SERVICE BULLETIN

#A5-67

SUBJECT: PUMP INLET CHECK VALVE REDESIGN

CARBURETORS AFFECTED: ALL MODEL MA-4-5, MA-6 AND AA SERIES.

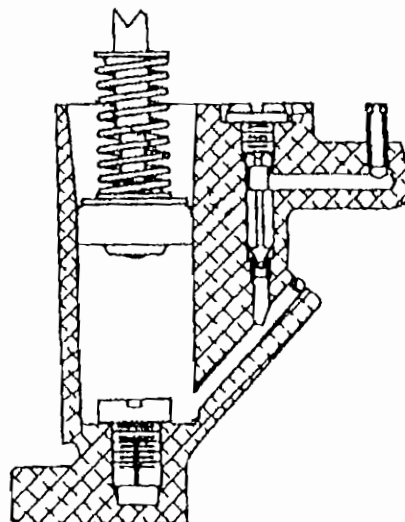
WE HAVE REDESIGNED THE PUMP INLET CHECK VALVE. INCORPORATING A LONGLOC INSERT IN THE THREADS, AS THE SAFETYING METHOD, ENABLED US TO ELIMINATE THE OLD STYLE SPRING LOADED BALL RATCHET.

OLD STYLE (36-539)
KNURLED HEAD USED WITH BALL
SAFETY RATCHET

NEW STYLE (36-587) ✓
PLAIN HEAD WITH LONGLOC THREAD
INSERT - NO SAFETY RATCHET REQUIRED

THE NEW LONGLOC STYLE WILL REPLACE THE OLD IN ALL CASES.

CAUTION - DO NOT INSTALL THE OLD KNURLED HEAD TYPE IN A NEW STYLE BOWL WHICH DOES NOT HAVE PROVISION FOR THE BALL SAFETY RATCHET.
